**An Bord Pleanála Ref: PA 0034**

**Proposed Alexandra Basin Redevelopment**

**Reply to Request for Further Information**

**Fig. 2.1**

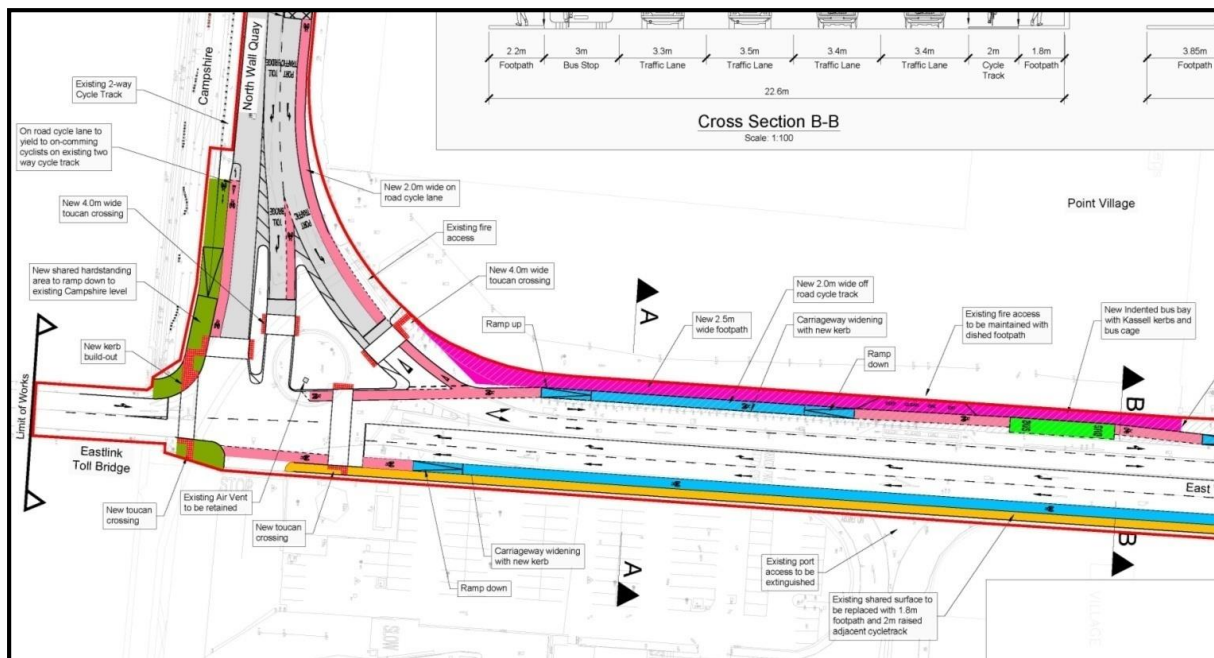
- *Pedestrian connectivity between the Campshire/Quay and Cruise area/ Interpretative zone;*
- *Connectivity between the cruise area and Luas/North Docklands; and*
- *Connectivity for bus traffic to the amenities of the City, which might consider more direct alternatives to the proposed Promenade Road Route.*

Fig.2.1 below is an extract from the DCC/Arup drawing (Drg. Ref. No.TO100-01) relating to the pertinent section of the improvement scheme at the current Point/3Arena roundabout showing the planned pedestrian crossings.

The plan shows a signalised junction in place of the existing roundabout incorporating signalised pedestrian and cycle crossings at the northern side of the East Link Toll Bridge thus creating a direct and safe pedestrian link between the Campshires and the Cruise/Interpretive area.
